Addendum to the

MORRO BAY WATER RECLAMATION FACILITY PROJECT

Environmental Impact Report (State Clearinghouse No. 2016081027)

August 8, 2019

Figure 1

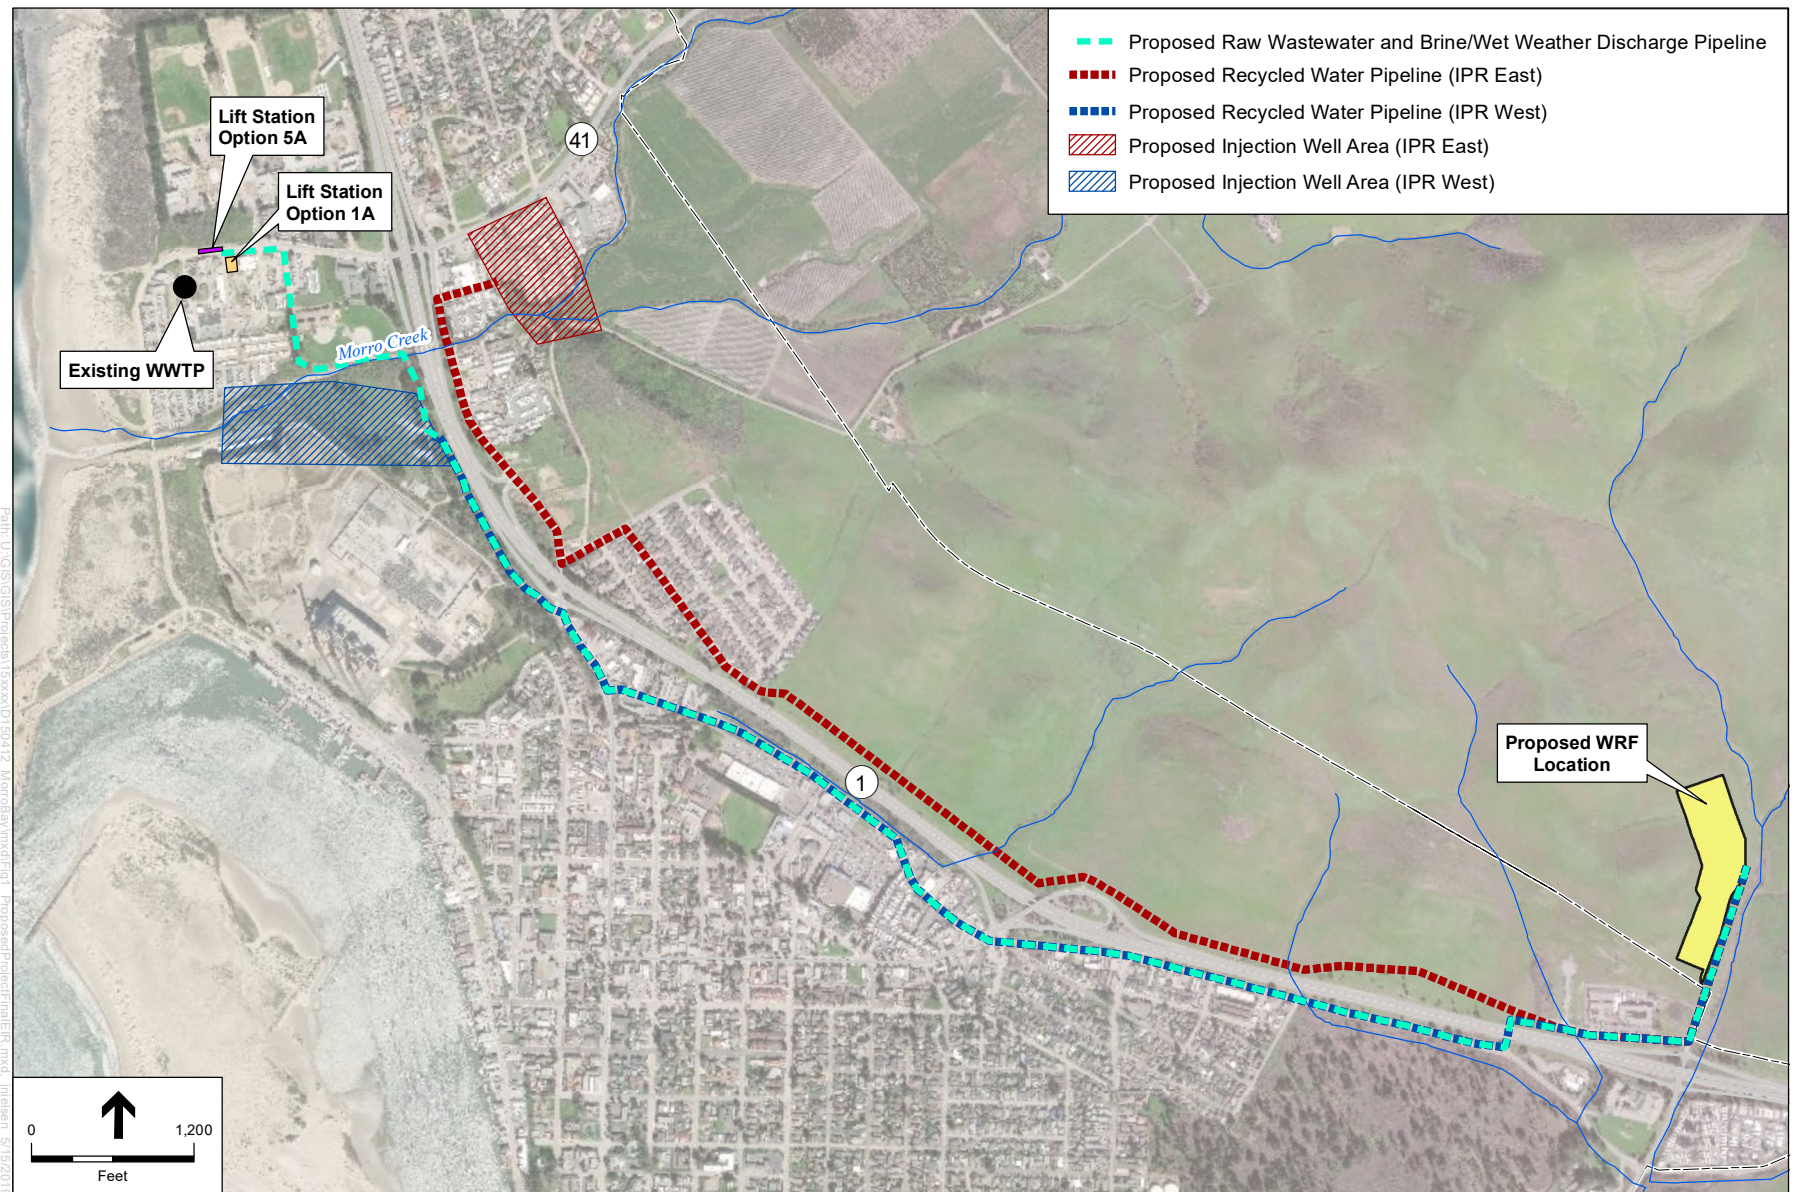
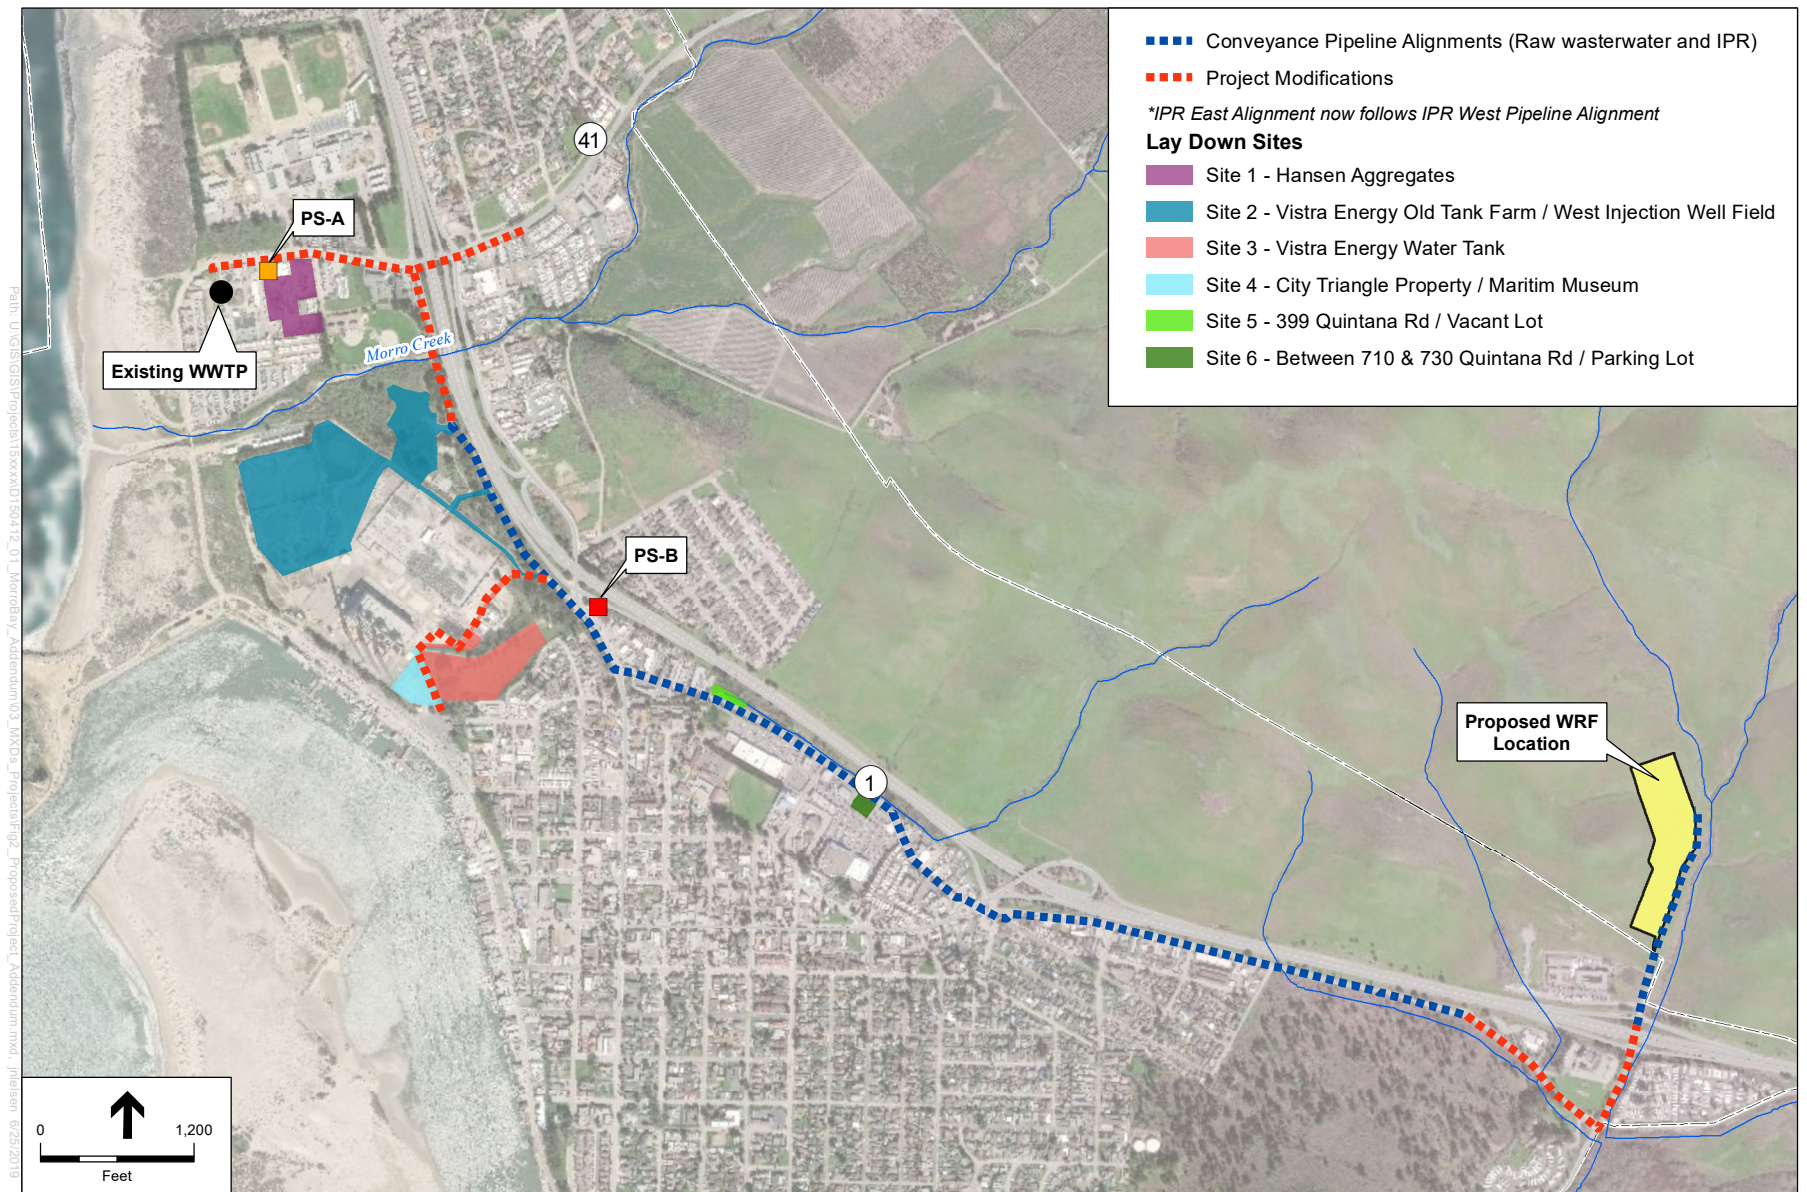
This Addendum identifies minor modifications to the existing project which includes the rerouting of conveyance pipeline alignments, addition of a new lift station, rehabilitation of the existing ocean outfall, and identification of potential construction laydown sites (**Figure 2**). The minor modifications to the project are further defined below:

- Northern Alignment Modifications
 - Re-routing the northern end of the conveyance pipeline's alignment to lift station (PS-A). The new alignment would continue north along Highway 1 and would then travel west along Atascadero Road rather than turn west at Lila Keiser Park. The new alignment would completely avoid Lila Keiser Park. This would avoid Native American burial sites previously identified in the Final EIR.

- Southern Alignment Modifications
 - Re-routing the southern end of the conveyance pipeline as it leaves the proposed WRF. The pipeline alignment modification would stay within South Bay Boulevard headed southwest under Highway 1, turning at the corner of Quintana Road rather than traveling north on Teresa Road as analyzed in the Final EIR. This new alignment avoids having to tunnel under Highway 1 and avoids crossing one jurisdictional feature, and avoiding utility conflicts in Teresa Road.

- The project modification would include a new lift station (PS-B) along the pipeline route. The lift station would be at the corner of Main Street, Quintana Road, and Highway 1, on a site owned by the City. It is currently a paved lot adjacent to a pet food store that is owned by the City. This project modification would allow for PS-A, which was included in the previous Final EIR, to be reduced in size/footprint, which would reduce the size of the facilities in the coastal flood hazard zone. Through the development of the detailed design for the lift station and pipelines, a second lift station was determined to be more cost and energy efficient.

- Utilizing new laydown areas for materials and equipment during construction (see Figure 2).
- Over nearly 40 years of operation, significant quantities of sediment have accumulated in the outfall. This project modification includes removal of approximately 30 cubic yards of accumulated sediment that was identified in the Morro Bay Outfall Inspection (Ballard Diving & Salvage, 2011). Following removal of the sediment, duckbill-style check valves will be installed on 28 of the 34 diffusers. The City is making a significant capital investment in the construction of a new WRF. Rehabilitation of the outfall will reduce the vulnerability of the City's overall wastewater treatment system and protect the City's new investment.

Figure 2
Project Modifications

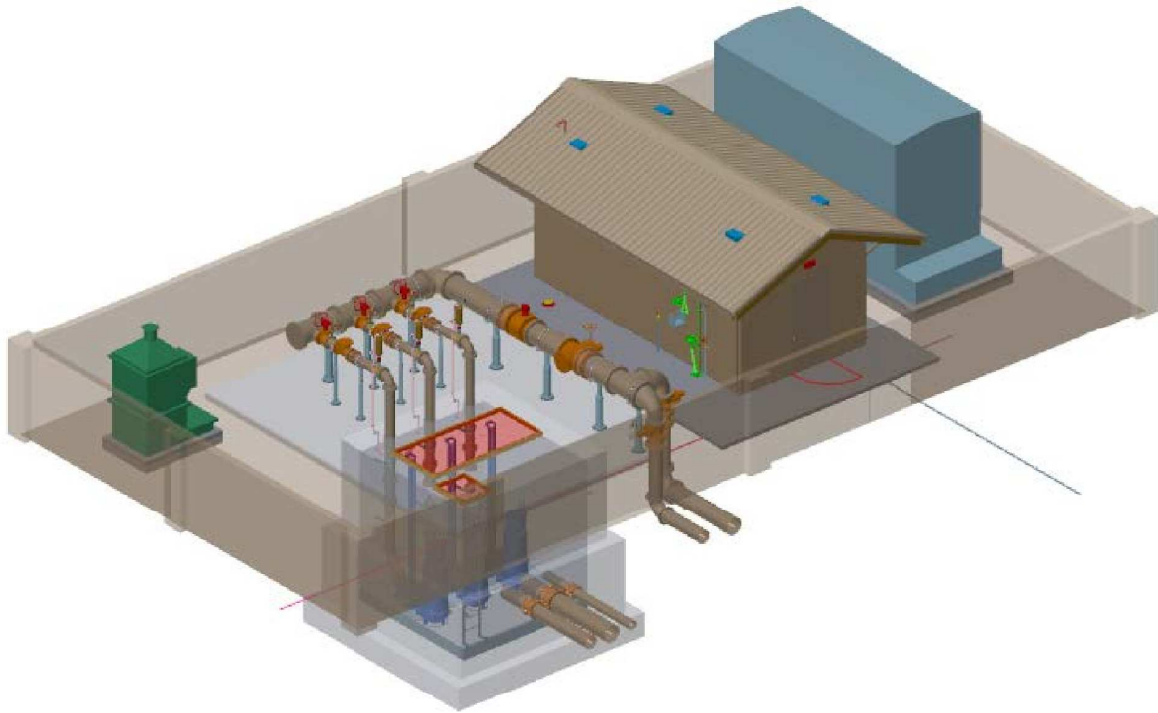
The purpose of modifying the raw wastewater pipeline alignment is to avoid sensitive resources. The proposed modification would avoid significant impacts to cultural resources. The northern end of the raw wastewater pipeline would deviate from the original alignment, now being routed from PS-A staying within the California Department of Transportations (CalTrans) right-of-way along Highway 1 and then heading down Atascadero Road to PS-A. This modified route would avoid potential impacts to Lila Keiser Park and previously identified Native American burial sites (see Figure 2).

Additionally, instead of constructing the recycled water pipeline along the east side of Highway 1 as analyzed in the Final EIR, the pipeline would now be on the west side of Highway 1, travel along the same alignment as the West IPR pipeline. The pipeline would then travel under Highway 1 near Highway within 41/Atascadero Road to the East IPR well injection field (see Figure 2). This alignment crossing was not proposed in the original Final EIR.

The proposed modification would include a new forcemain between LS-2 and PS-B. The capacity of the existing forcemain between LS-2 and the West IPR alignment would not be able to accommodate the future flows of the project. A larger forcemain would be needed to get flows from LS-2 to the new lift station PS-B adjacent to the West IPR alignment. The modification would include the abandonment of an approximately 1,163-foot portion of the existing 8-inch forcemain in place and the installation of approximately 1,910 feet of 12 to 14-inch diameter new forcemain to the southeast. The new alignment would run within the Pacific Gas and Electric

(PGE) property along the fence line (no impacts to PGE infrastructure), divert around the existing drainage area, and would connect with the remaining portion of the LS-2 forcemain within a paved road (see Figure 2).

The conveyance pipeline leaving the WRF would now travel along South Bay Boulevard and under Highway 1, turning at the corner of Quintana Road rather than traveling up Teresa Road and eventually crossing Highway 1. This modification in the pipeline alignment would avoid having to tunnel under Highway 1 and crossing jurisdictional wetlands (see Figure 2).

PS-B 3-D Rendering

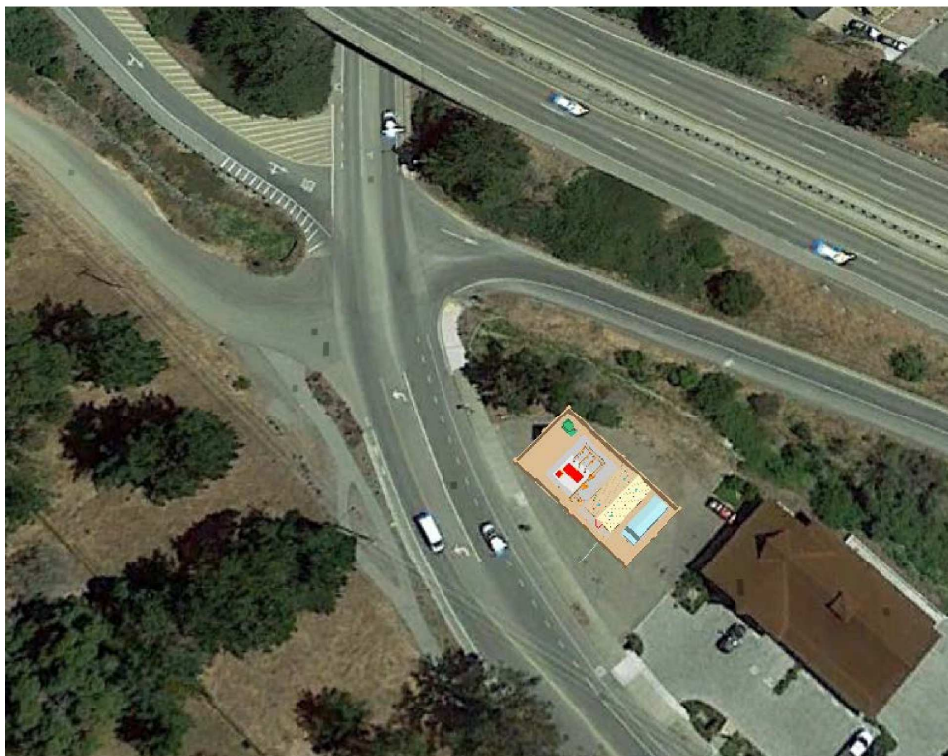
The proposed modification includes the addition of a new lift station to the proposed project. PS-B would be located at the corner of Main Street and Highway 1, on a property owned by the City. It is currently a paved lot adjacent to a pet food store. Similar to PS-A, PS-B would include a 2,600-square foot concrete masonry unit (CMU) building to house the electrical equipment needed to support the lift station. The electrical building will have a total height of 15 feet above existing grade. The lift station would include a CMU perimeter wall to prevent unauthorized individuals from accessing the approximately 8,600-square foot site (**Figure 3**). PS-B would require a total of three 250-hp pumps.

This project modification would allow for PS-A, which was included in the Final EIR, to be reduced in size/footprint. As included in the Final EIR, a single pump station would require two sets of pumps, one set of pumps would handle low flows and one set of larger pumps would handle high flows. With a single pump station, a total of eight pumps would be required including two 60-hp and size 250-hp resulting in a total connected load of 1,620 hp. With the addition of PS-B, PS-A would only require three 60-hp pumps. The result of adding PS-B is a reduction in the net connected load for project of 690 hp compared to the single pump station alternative included in the Final EIR.
